PLANNING RESPONSES
SUNLIGHT HOUSE
OCTOBER 2024

GROUND FLOOR CAFE GLAZING

CDN/24/0714 & CDN/24/0713

This document forms a response to CDN/24/0714 (Condition 7) and CDN/24/0713 (Condition 11). Some areas of this glazing had to be revisited and redesigned in line with the Fire requirements and to support the latest reception layout and cafe testfits.

GROUND LEVEL PLAN

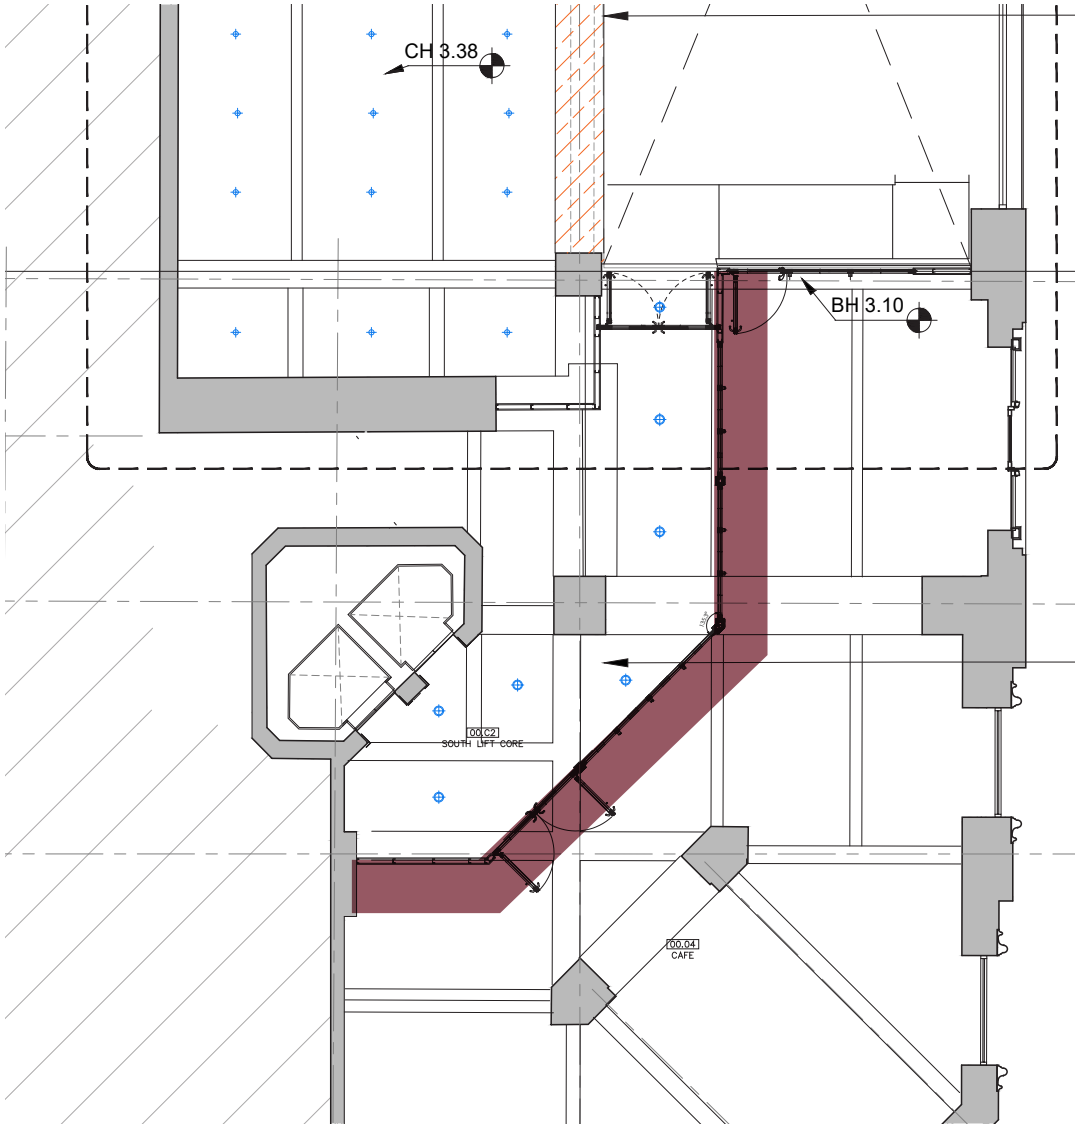
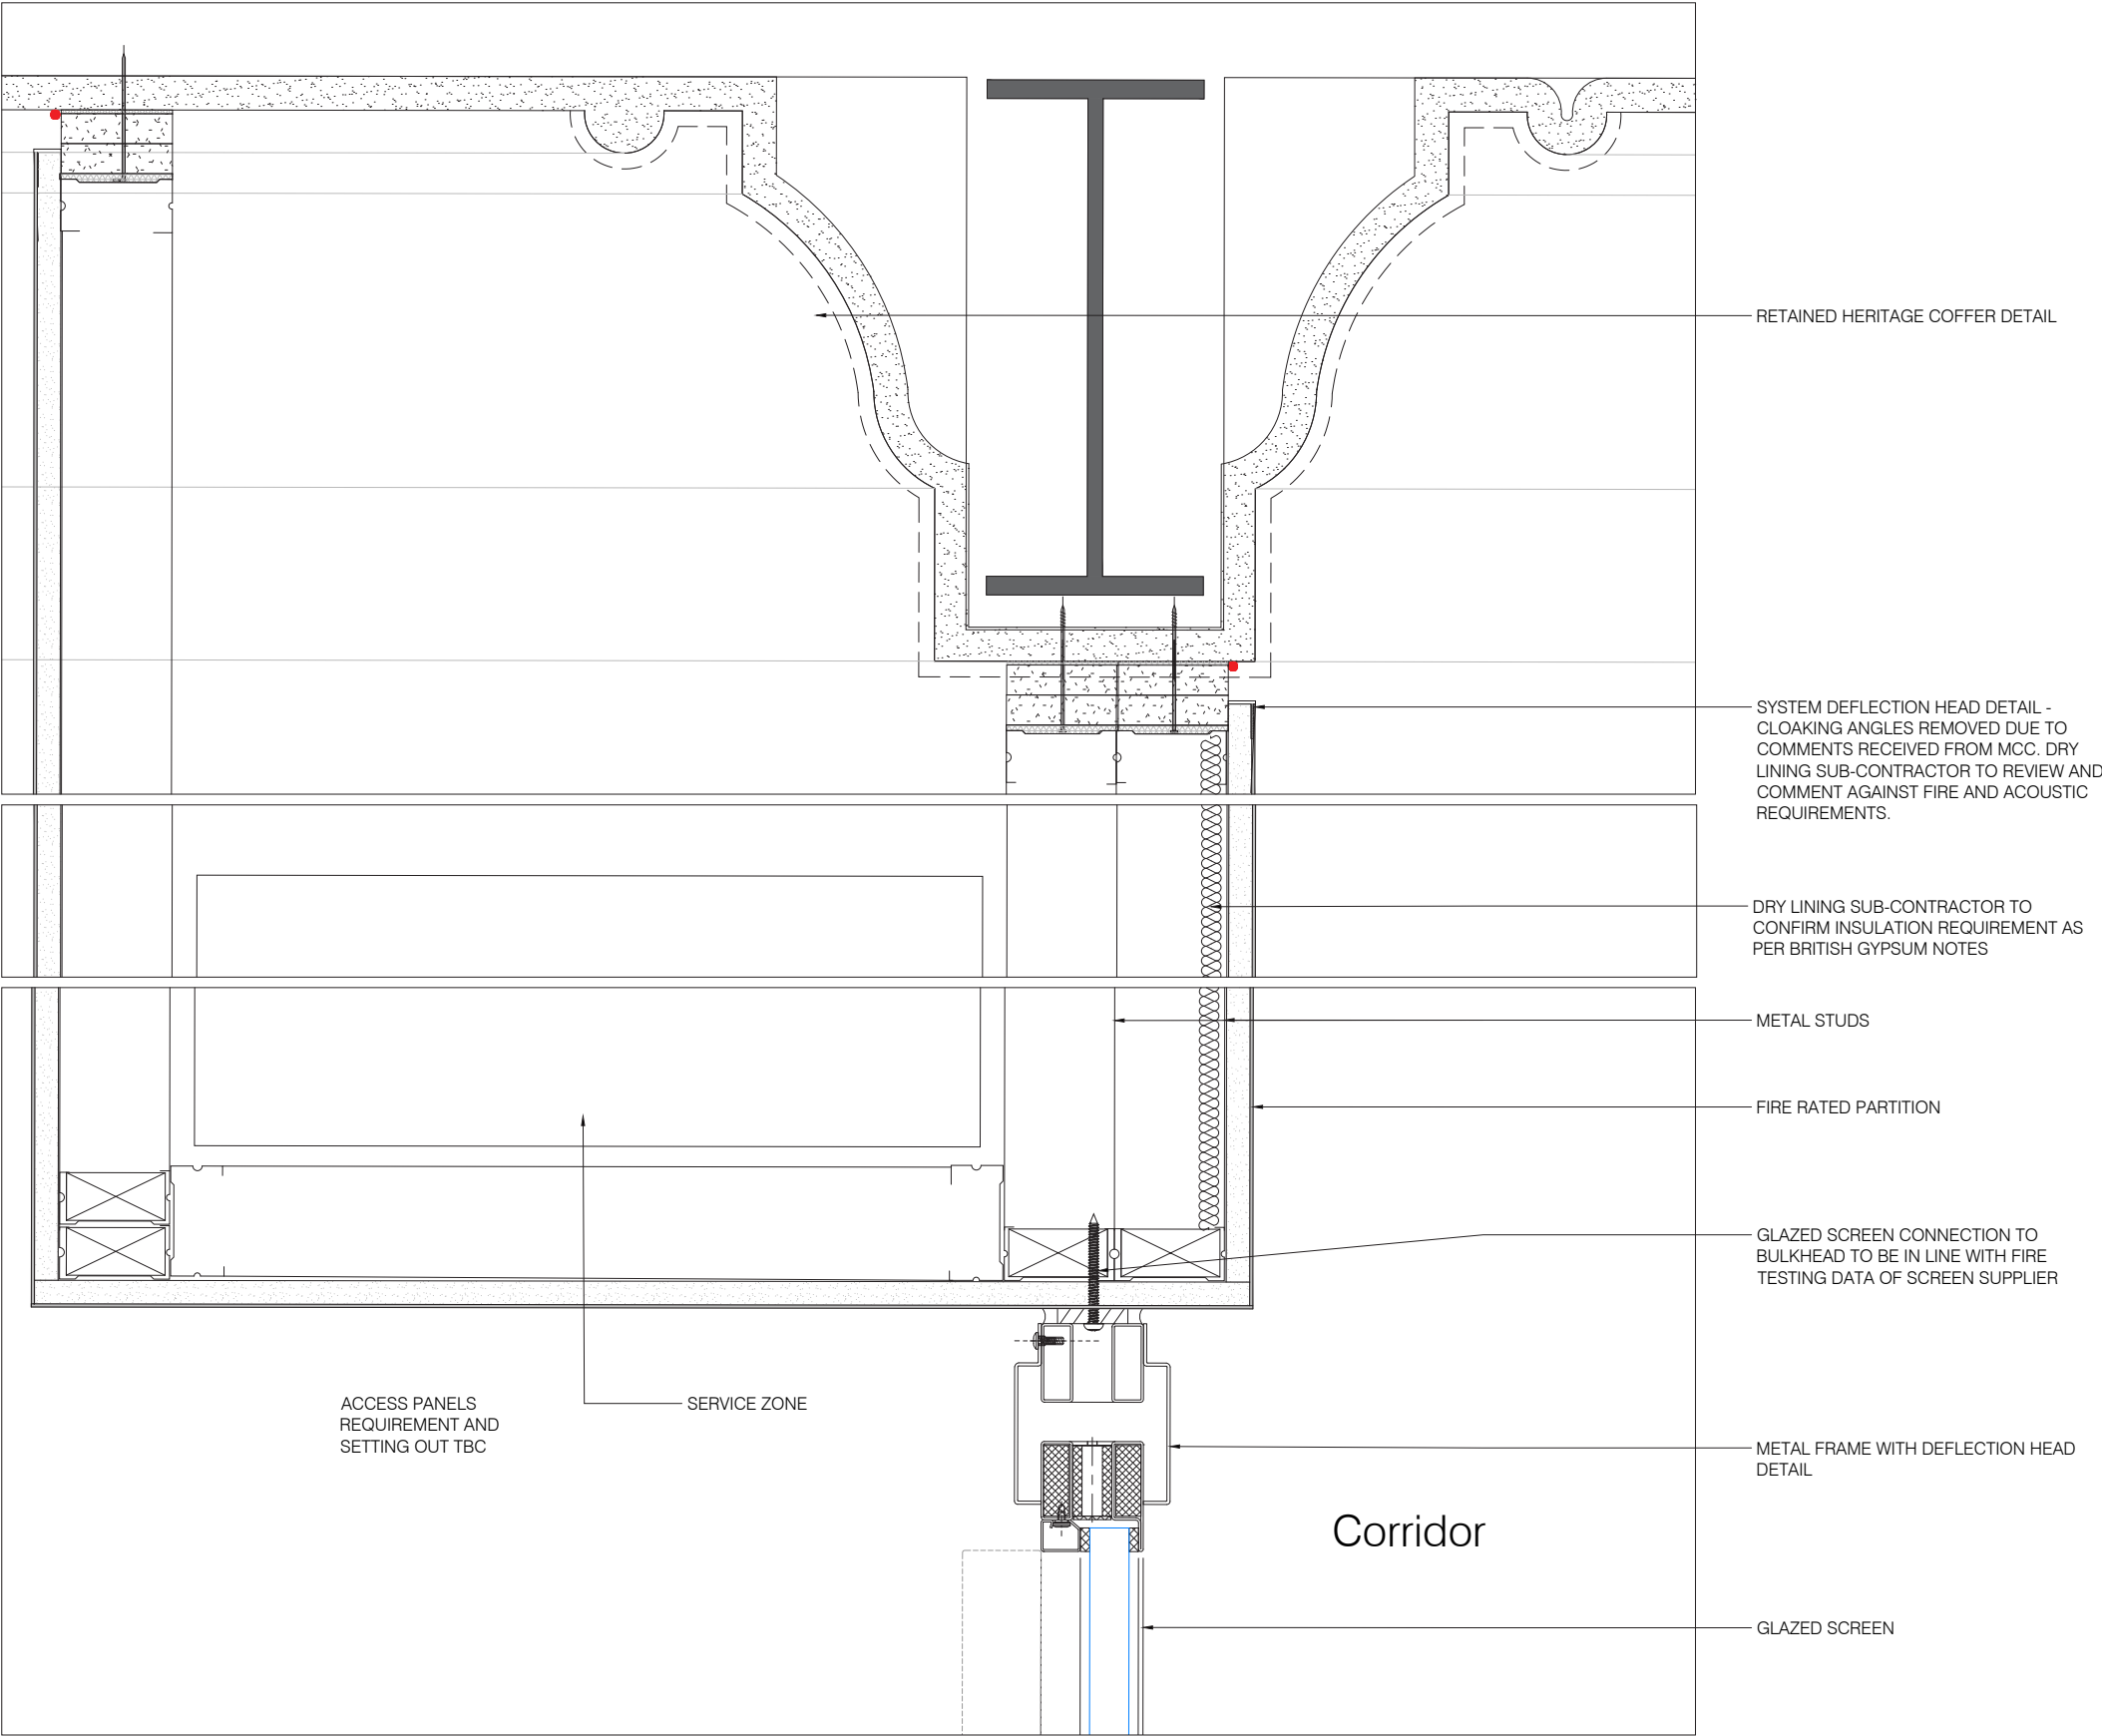
The new detail proposed will apply to the glazed café partition on the ground floor to allow for boxing out of services along this route. Services within will accomodate the café unit.

The remaining part of this area remains as exposed coffer

Proposed location of new bulkhead

PLASTERBOARD PARTITION BULKHEAD DETAIL

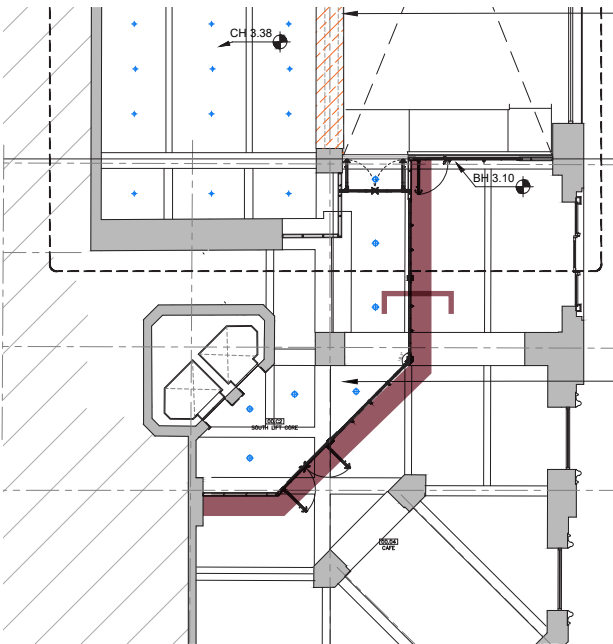
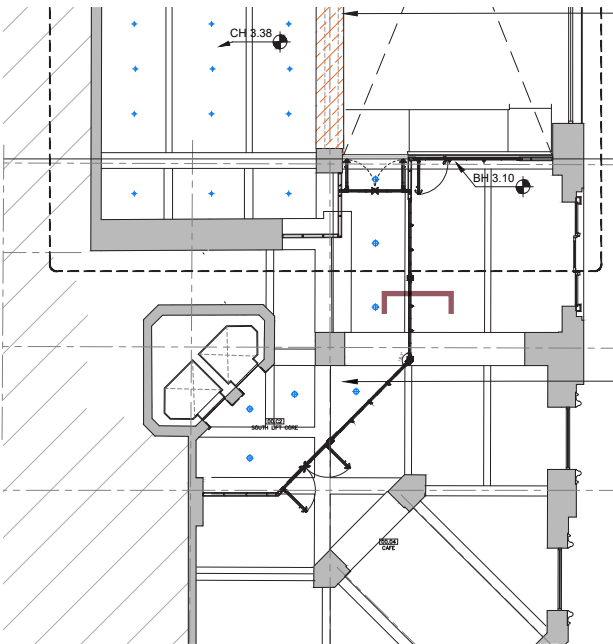
The plasterboard bulkhead will back out onto the café area and will be accessed through access panels throughout. Along the corridor side, the bulkhead will sit flush with the Optima glazing panels and align to the edge of the coffer. The café will house the plasterboard bulkhead in order to keep the corridor coffered ceiling exposed.

The new proposed bulkhead detail allows for boxing out of services along the ground floor. This also protects the existing historical fabric from any unnecessary modifications.

The dimmensions of the plasterboard as also dictated by the fire requirement of 60min FR on this partition line.

SECTION OF THE CORRIDOR

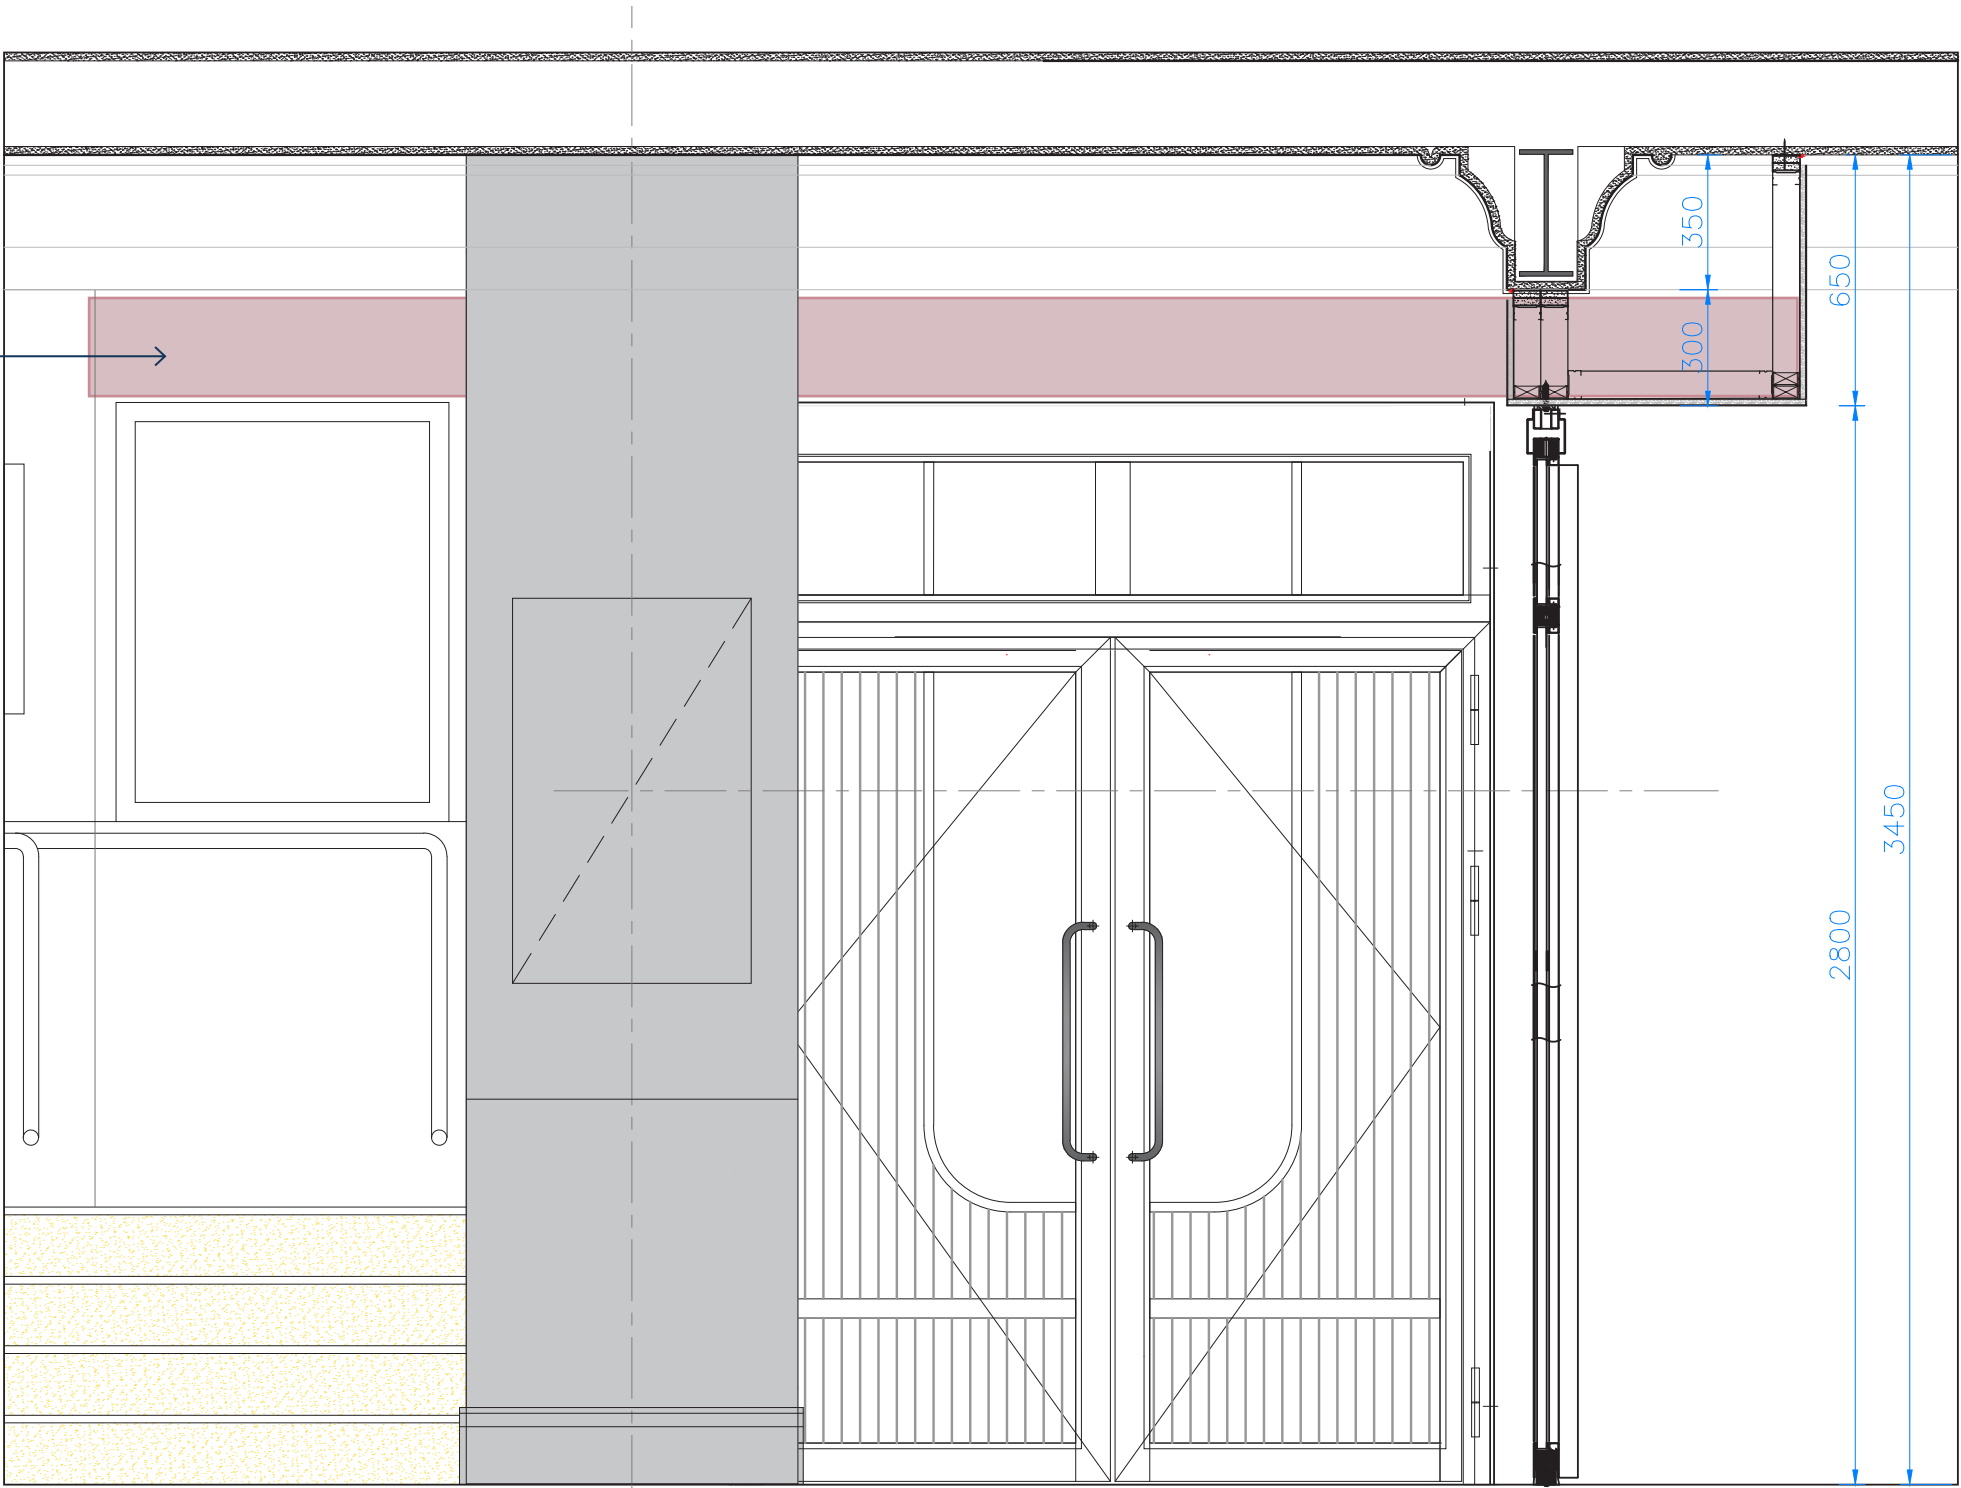
Beam heights vary, with the lowest beam being at 3100mm in this area.
All glazing is to uniform height of 2800mm leaving 300mm for the service zone under the historic coffer.

SERVICE ZONE
300mm under the
historic coffer
